Response to TCDC proposal Island View

Ian Holyoake 29 October 2023

I do not like the proposal: The design is intended to be part of the the Stormwater assets of Whangamata resource consent 105667 but does not provide storm-water benefit.

174 mp4 showing both pipes.jpg

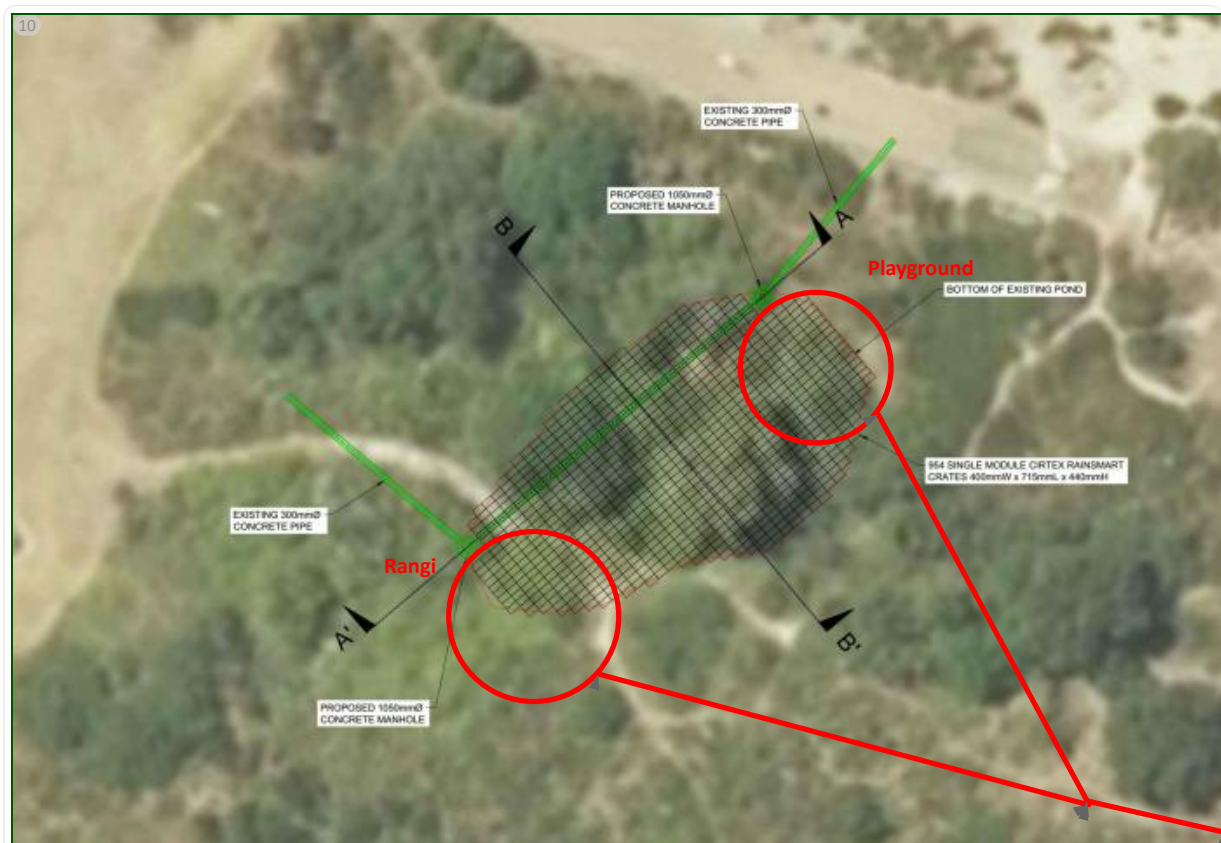
No water exiting either pipe.

More likely residual rainwater from earlier rain.

200 TDCD plan view Cirtex.jpg

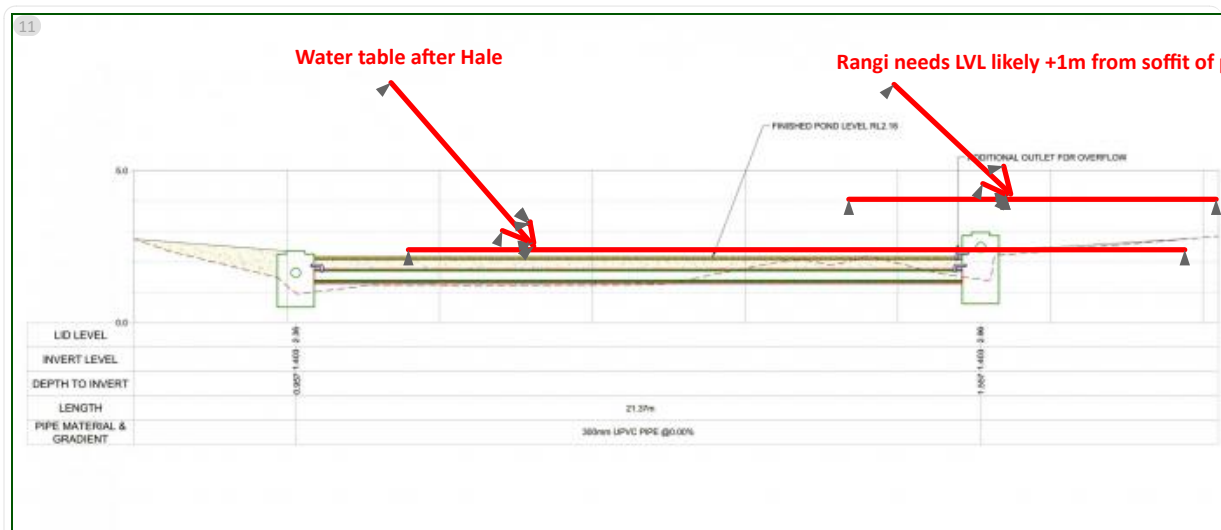
I don't accept that the entire basin needs to be Cirtex. I agree with the manholes as the catchpit for solid particulates.

The Cirtex can be minor because soakage devices are NOT part of a 10%AEP. The soakage devices can be small to cater for minor rainfall events and then overflow into the basis as a short term holding pond and piped out once the depth got over say 100mm. The circles represent the pond sizes and the red lines pipes into the Ocean.

NOTE: I do not want pipes discharging into the Ocean BUT we have no choice because we cannot get all pipes to Otahu river. If we could that would be great BUT it still means discharge somewhere.
